REPLAT AND SUBDIVISION PLAT ESTABLISHING  
MARBACH GARDENS SUBDIVISION UNIT 3  
BEING A REPLAT OF A PORTION OF A 47' DRAIN ESM'T. (0.034 AC.), VARIABLE WIDTH FILL ESM'TS. (1.546 AC. TOTAL) AND A SUBDIVISION PLAT OF 8.915 ACRES OF LAND OUT OF N.C.B. 15494, SAN ANTONIO, BEXAR COUNTY, TEXAS AND CONTAINING A TOTAL OF 10.495 ACRES OF LAND.  
THIS PLAT OF MARBACH GARDENS SUBDIVISION UNIT 3 HAS BEEN SUBMITTED TO AND CONSIDERED BY THE PLANNING COMMISSION OF THE CITY OF SAN ANTONIO, TEXAS AND IS HEREBY APPROVED BY SUCH COMMISSION.  
DATED THIS \_\_\_ DAY OF \_\_\_ A.D., 1999.  
THE PLANNING COMMISSION OF THE CITY OF SAN ANTONIO, TEXAS  
BY: \_\_\_\_\_ CHAIRMAN  
BY: \_\_\_\_\_ SECRETARY  
STATE OF TEXAS )  
COUNTY OF BEXAR )  
I, \_\_\_\_\_ COUNTY CLERK OF SAID COUNTY DO HEREBY CERTIFY THAT THIS PLAT WAS FILED FOR RECORD IN MY OFFICE, ON THE \_\_\_ DAY OF \_\_\_ A.D. AT \_\_\_ M, AND DULY RECORDED THE \_\_\_ DAY OF \_\_\_ A.D. AT \_\_\_ M, IN THE RECORDS OF \_\_\_ OF SAID COUNTY, IN BOOK VOLUME \_\_\_\_\_.

Re: Marbach Gardens (Revised)                      POADP # 531A

The City Staff Development Review Committee has reviewed Marbach Gardens Preliminary Overall Area Development Plan revisi

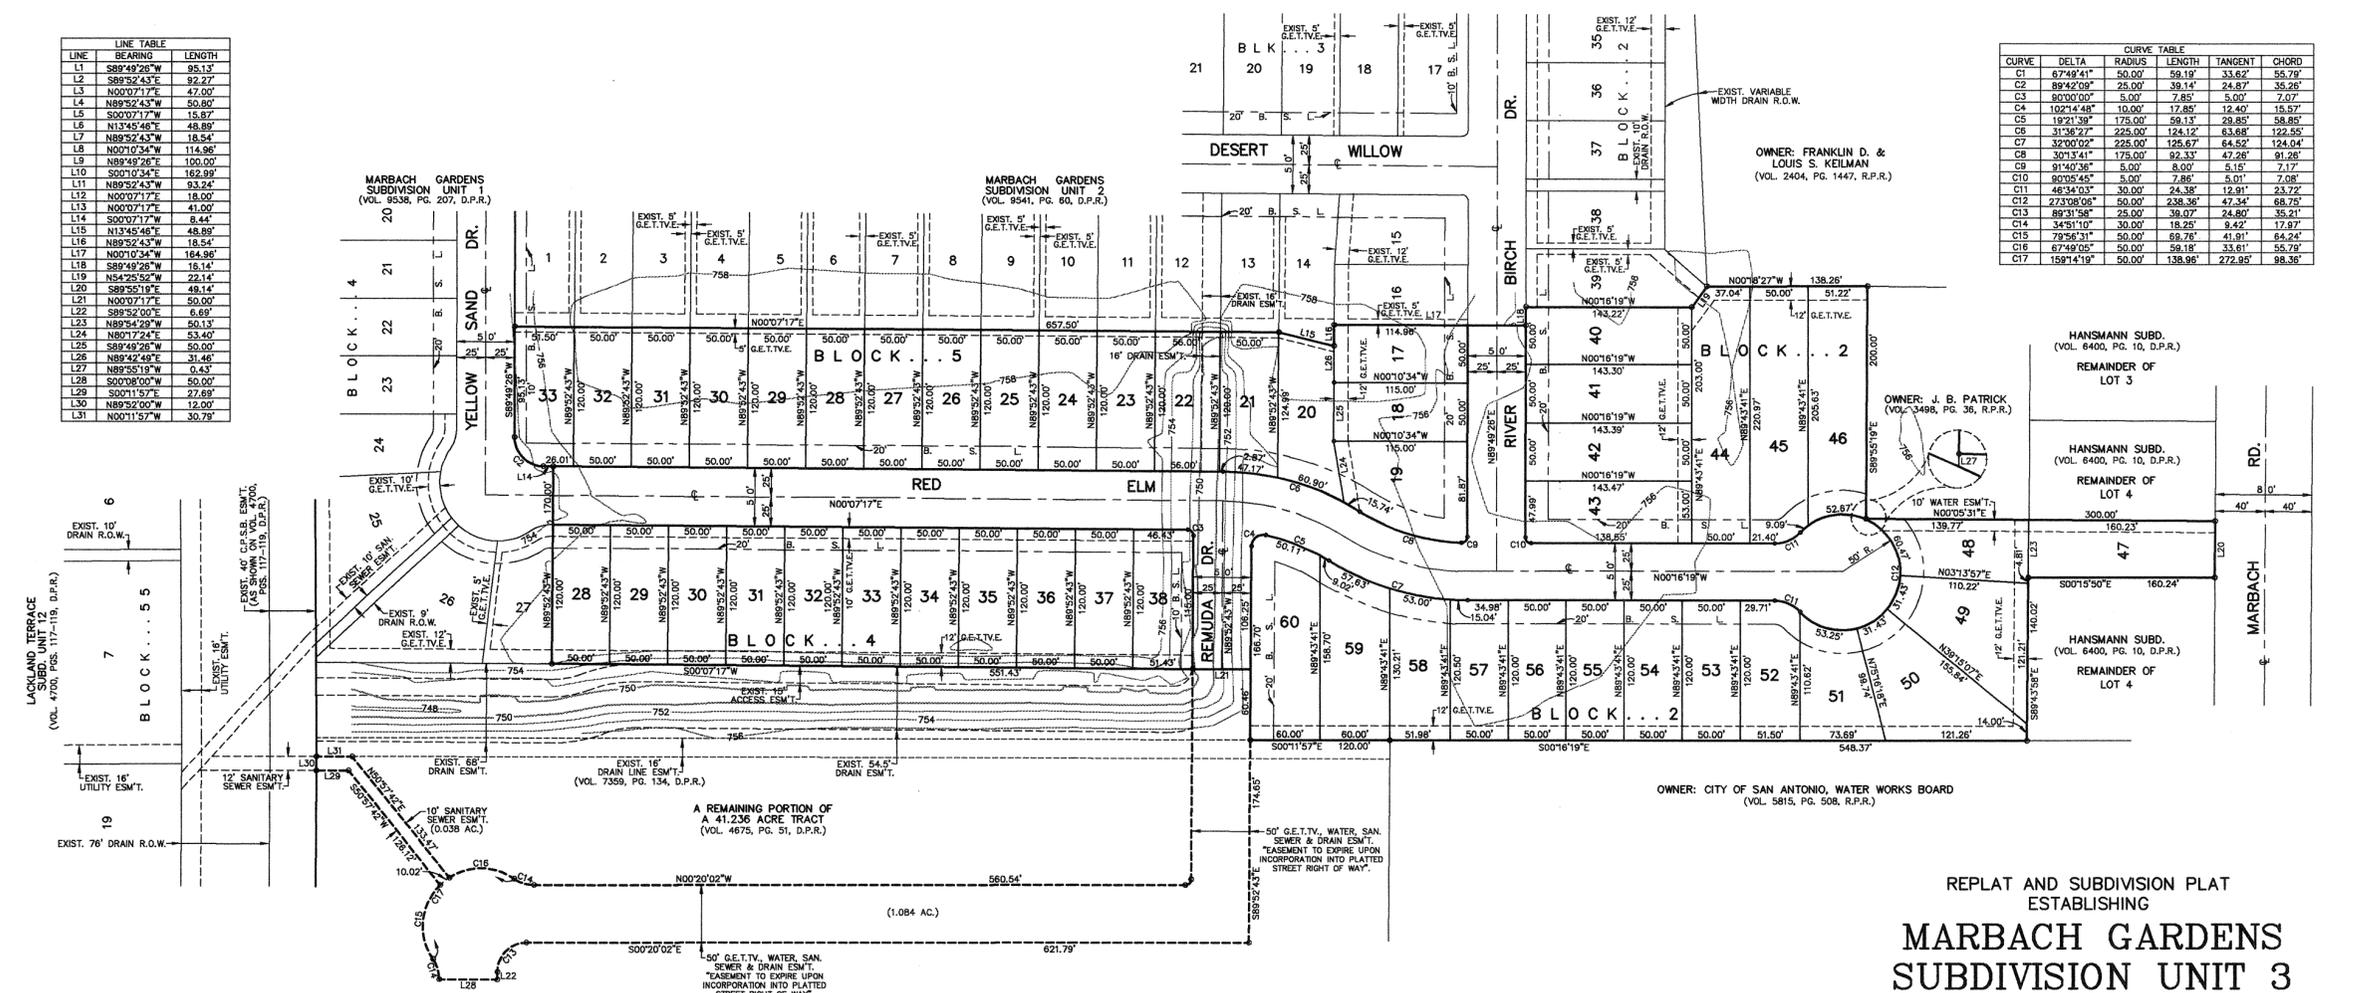
- Based on the topography, a Flood Plain Study and drainage review will probably be required during the platting process.
- In consideration of public safety and convenience, excessive grades by reason of topography should be avoided in street layouts and arrangements.
- This development may need to comply with tree preservation ordinance #85262. For information about these requirements you can contact Building Inspections at 207-7102.
- It will be expected that you will plat all of the property depicted in your POADP, to include: floodpains, drainage areas and open space.
- I would encourage you to work closely with the school district, so that they can plan accordingly.

Please note that this action by the committee does not establish any commitment for the provision of utilities, services or zoning of any type now or in the future by the City of San Antonio. If the proposed development is not platted in phases this POADP will be invalid. Platting will have to comply with the UDC.
